ADDENDUM NO. 3
TO THE CONTRACT DOCUMENTS

Date: June 11, 2015
Project No.: 497074

CROSTOWN WATER TREATMENT PLANT IMPROVEMENTS BID #960-B
FAYETTE COUNTY WATER SYSTEM
FAYETTE COUNTY, GEORGIA

**ELECTRICAL
FILTERS 1 TO 8
FILTER CONSOLE GALLERY
PLAN**

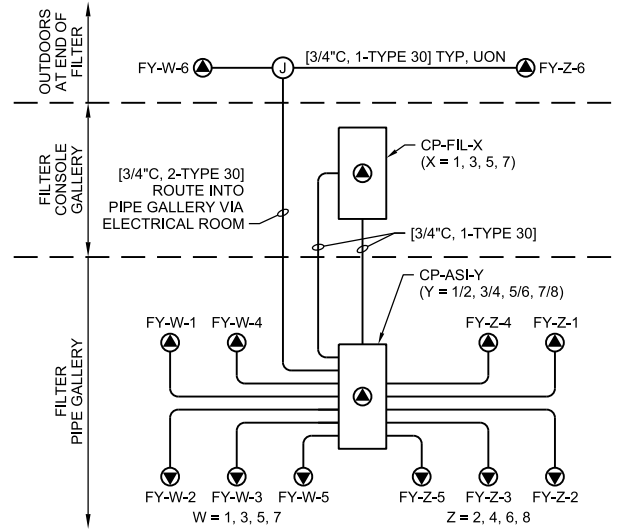
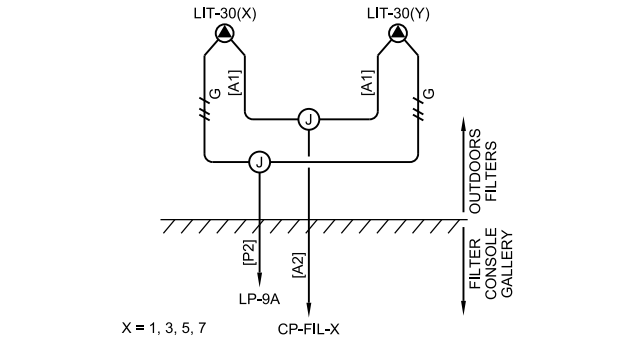
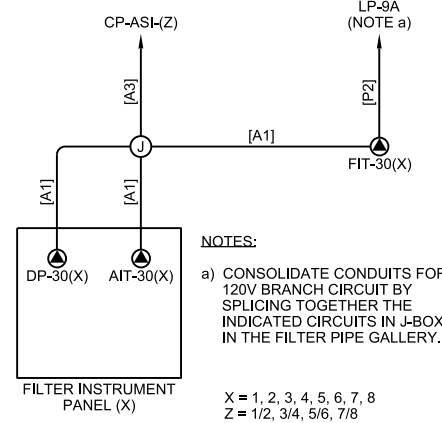
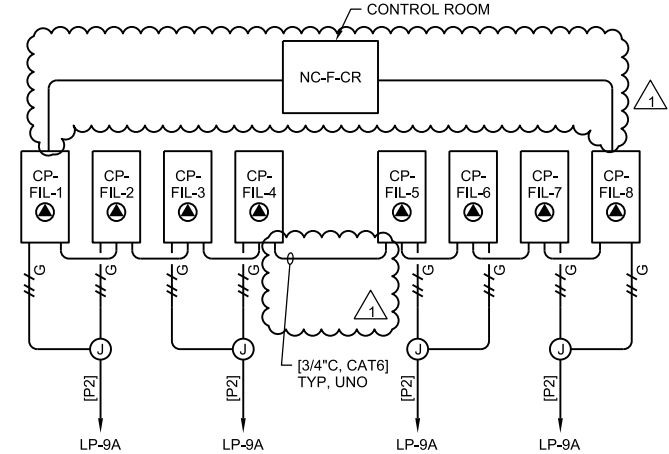
NO.	DATE	REVISION	CHK	DR	APVD
1	06/2015	FILTER CONSOLE COMMUNICATIONS

MCC-9 ONE LINE DIAGRAM
 NTS

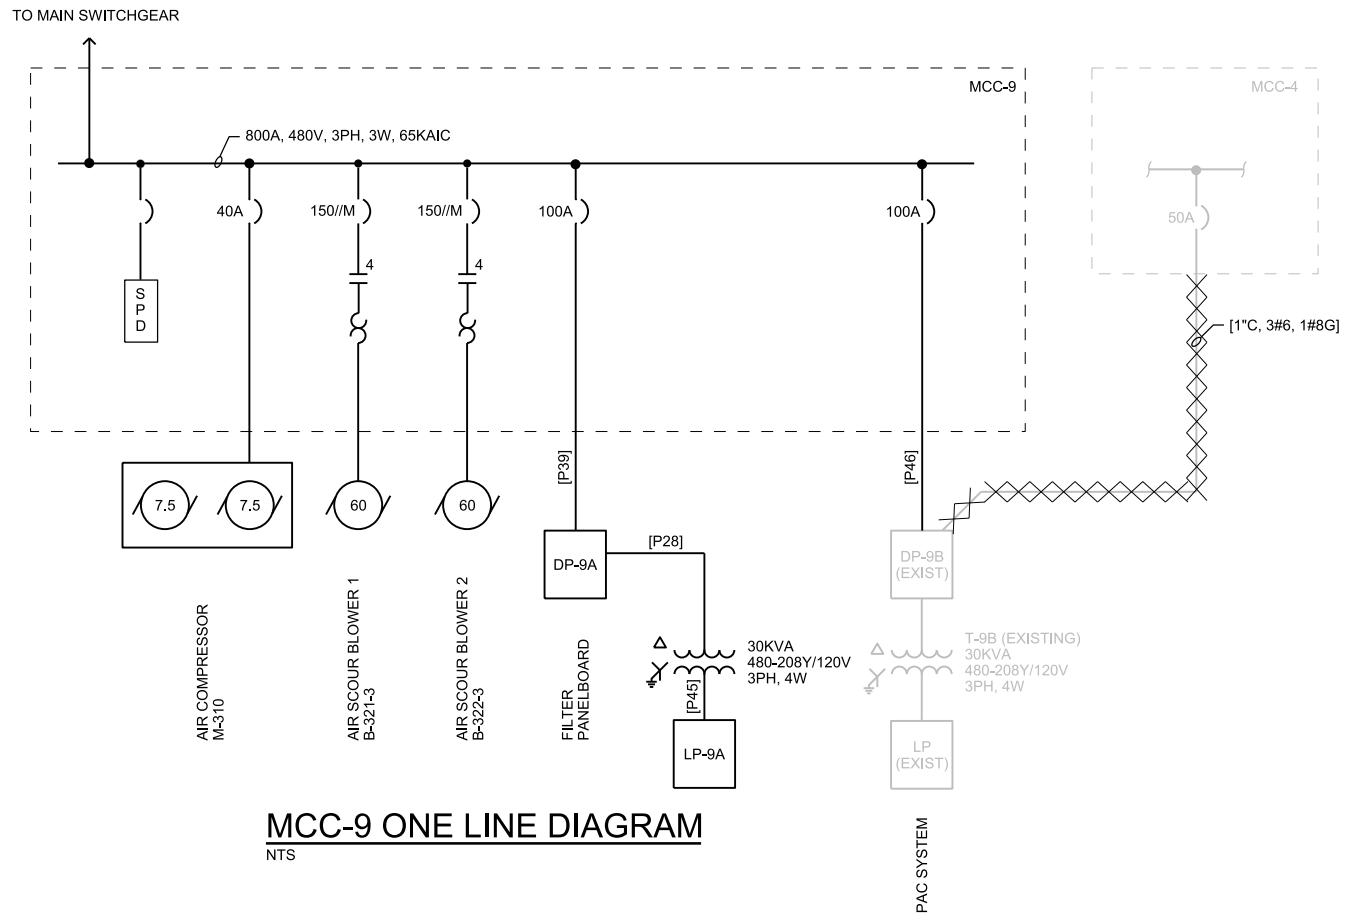
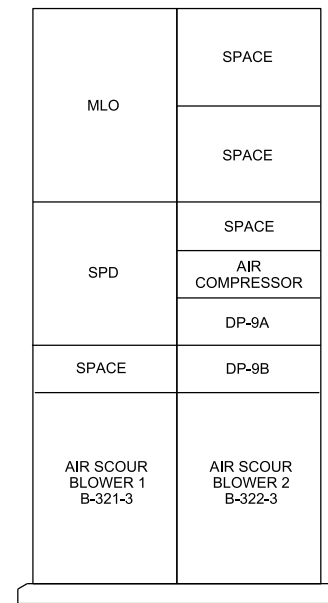
NO. 1 DATE 06/20/15
 DSGN N MEYER
 DR N MEYER
 CHK G MESSER
 REVISION BY APVD N MEYER
 FILTER CONSOLE COMMUNICATIONS MH NM
 FILTER CONSOLE COMMUNICATIONS MH NM
